1. SUBMITTAL TYPE: (Is this a resubmittal? Yes ☐ No ☒)			
Deferred Submittal ☐	Addendum Number: 01	Revision Number:	CCD Number: Category A ☐ or B ☐
2. PROJECT INFORMATION:			
School District/Owner: San Beranrdo City USD		DSA File Number: 36 H7	
Project Name/School: Indian Springs HS - Health Center		DSA Application Number 04 123900

ADDENDUM NO. 1

Indian Springs High School – Health Center

DSA #04-123900 FILE #36-H7 RCA Project No. 1-78-50

WALL SECTION 10
SCALE: 1/2" = 1'-0"

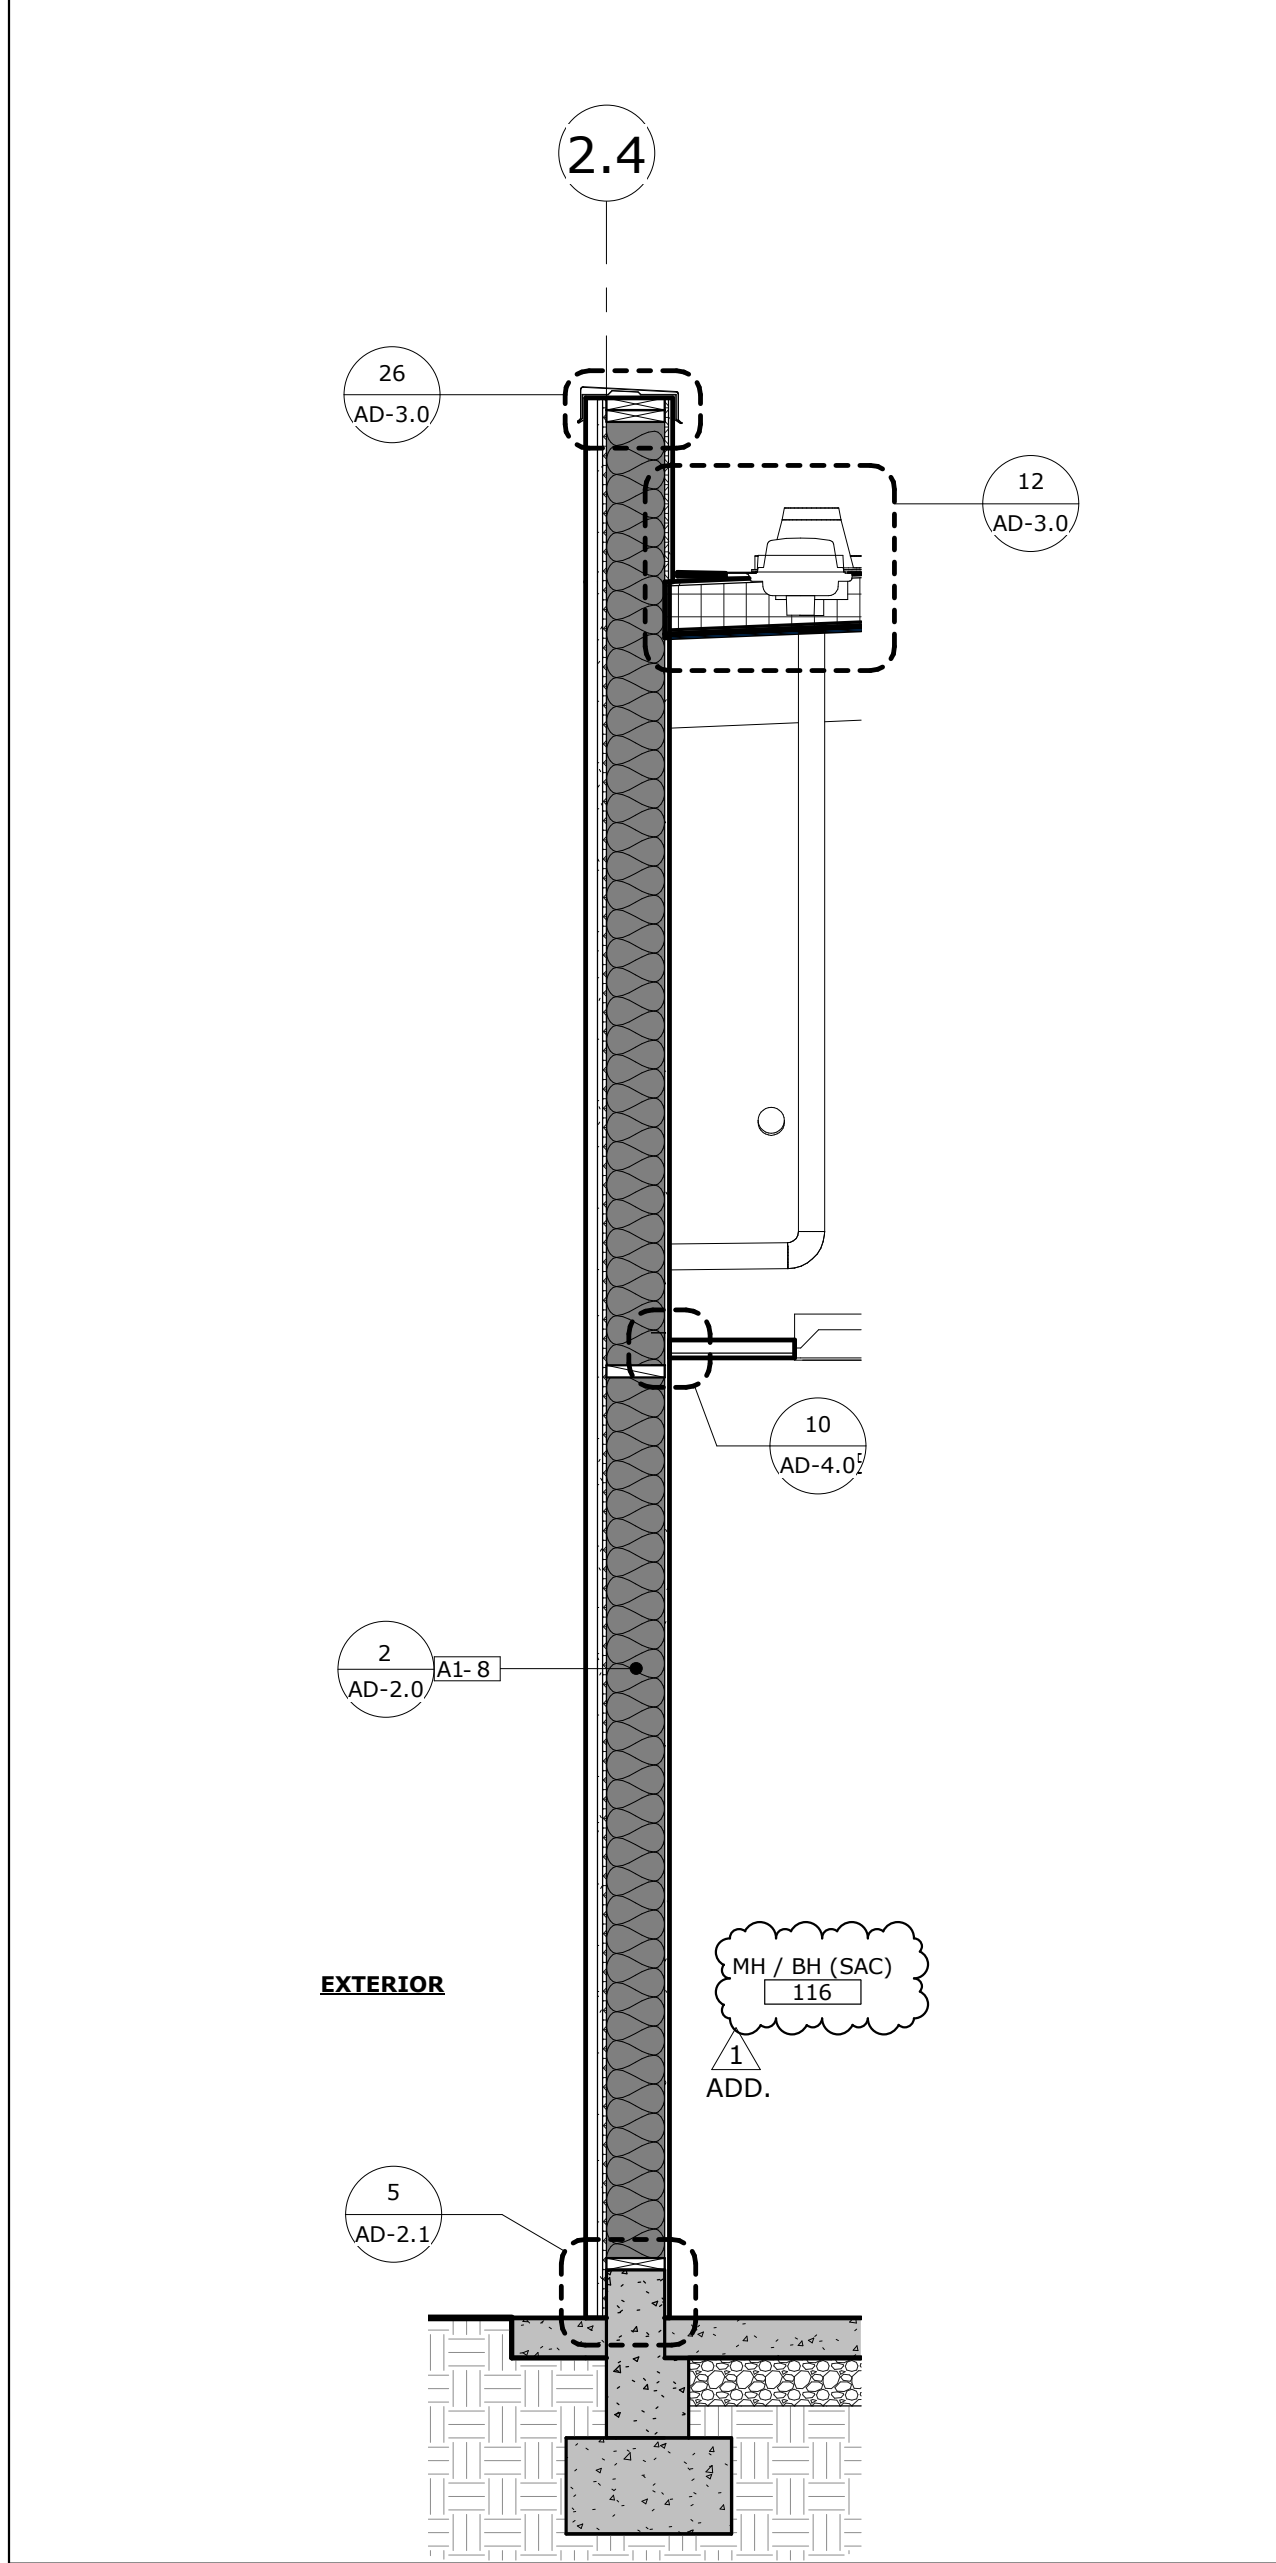
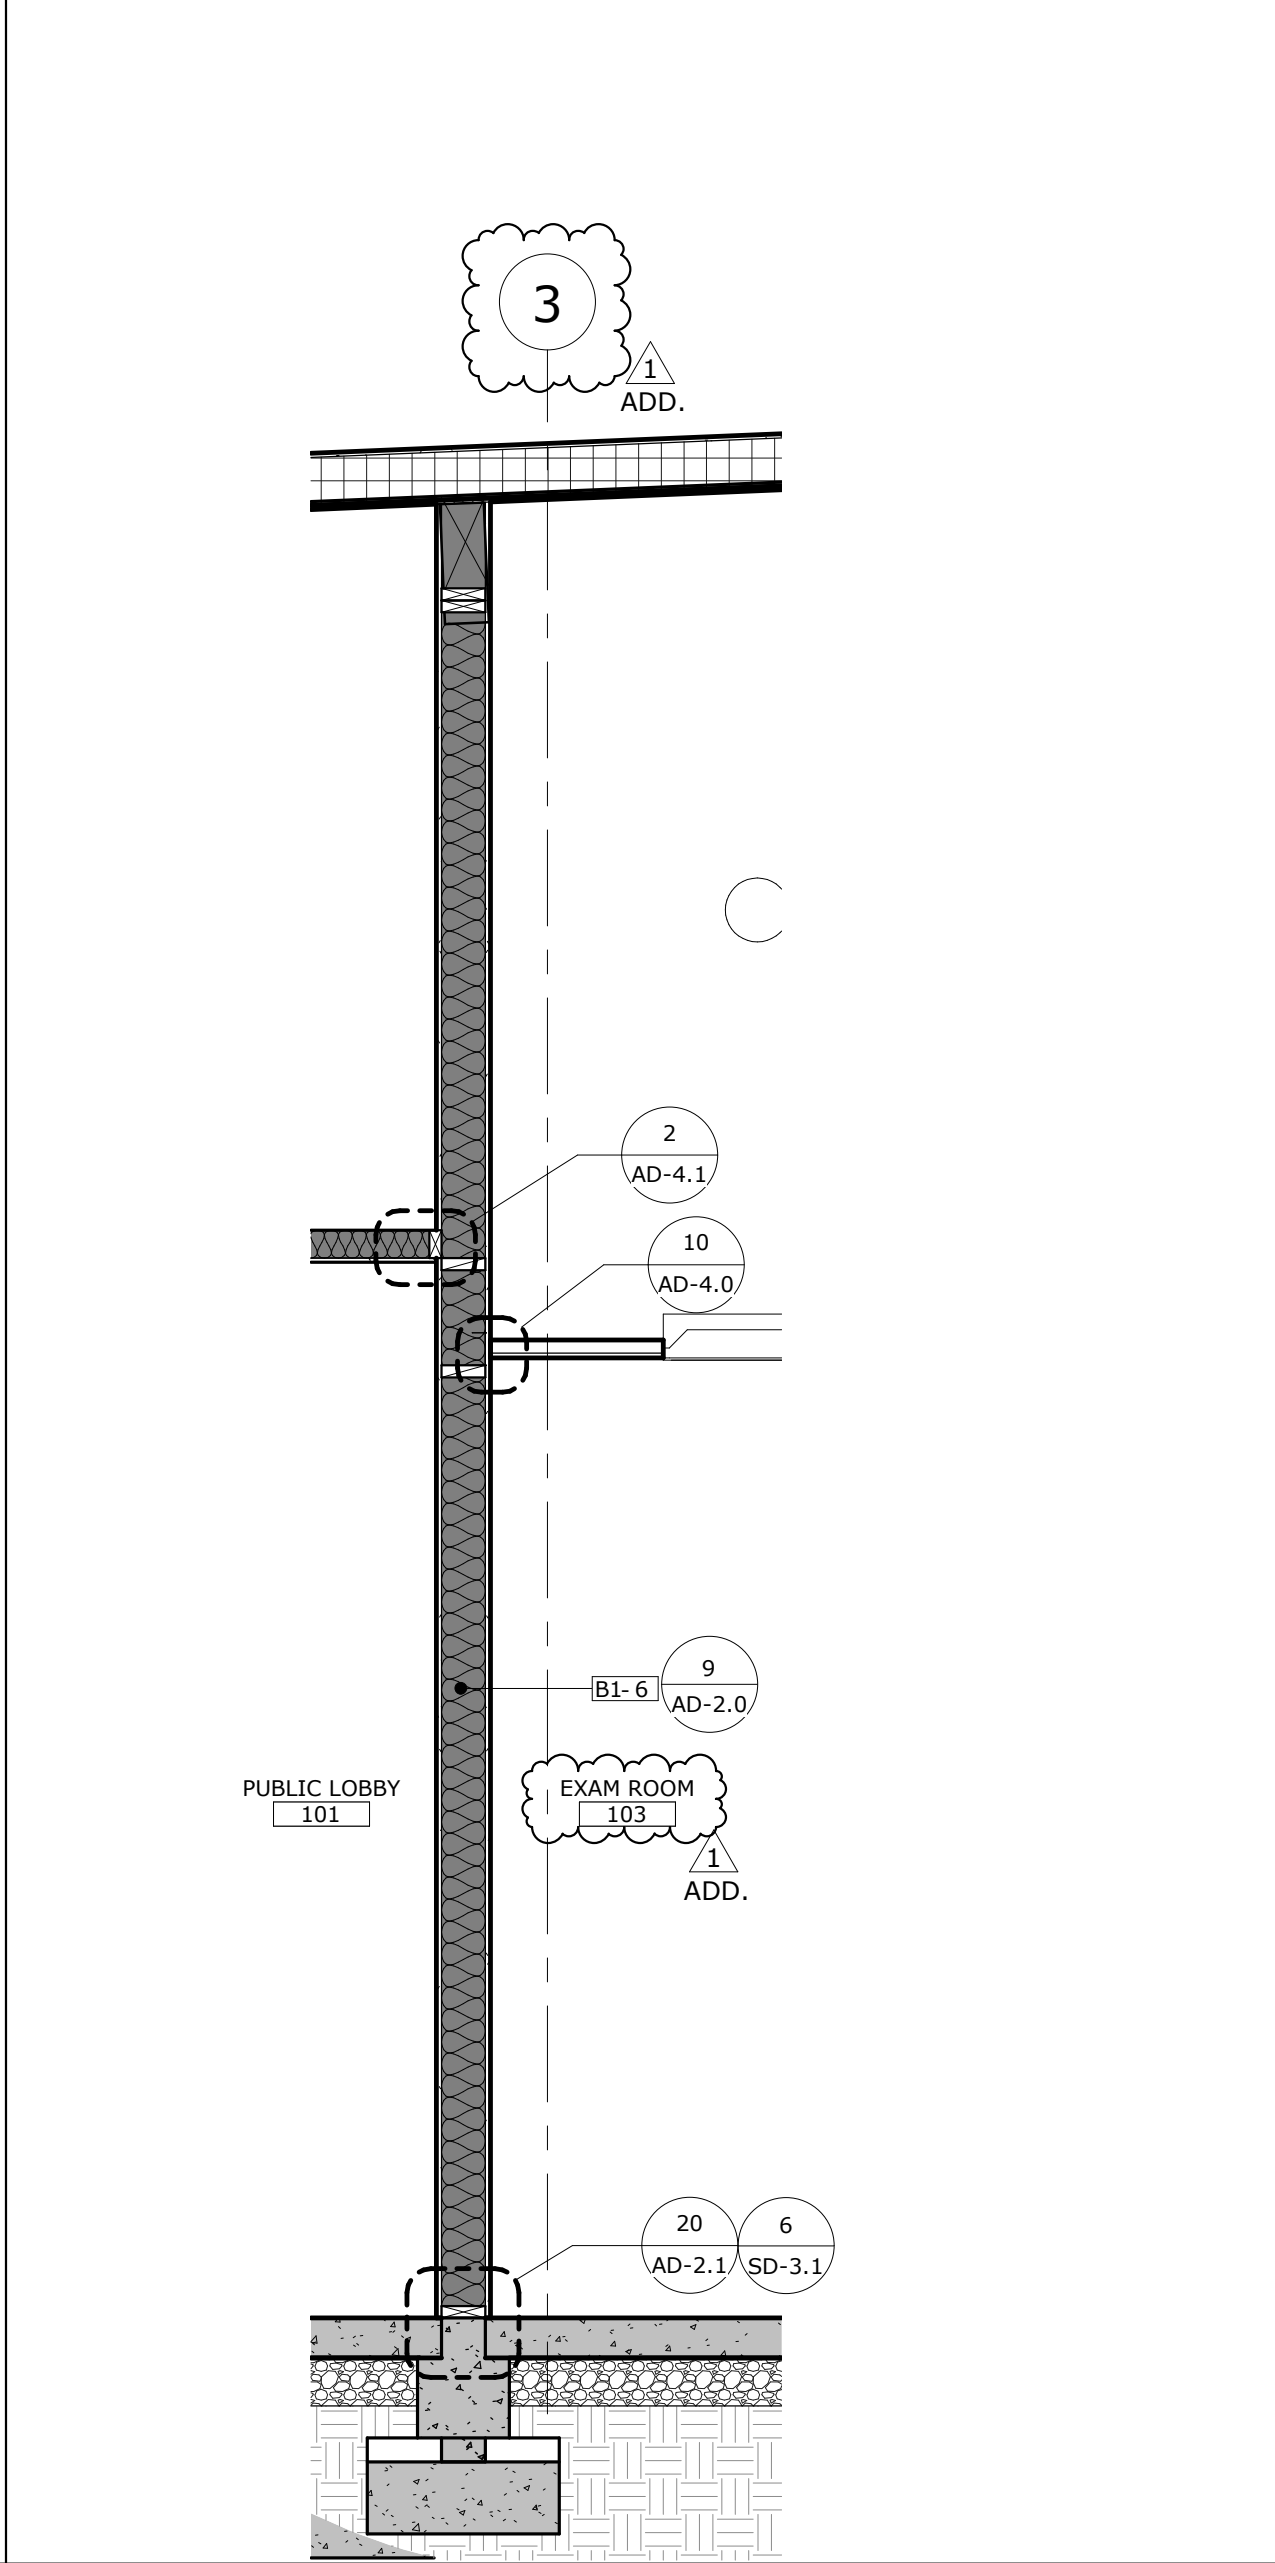
- Item No. 1.13 Reference Sheet A1-6.0 – WALL SECTIONS
1.13.1 Replace Sheet A1-6.0 and revise per clouded areas
- Item No. 1.14 Reference Sheet A1-7.0 – ENLARGED PLANS / INTERIOR ELEVATIONS
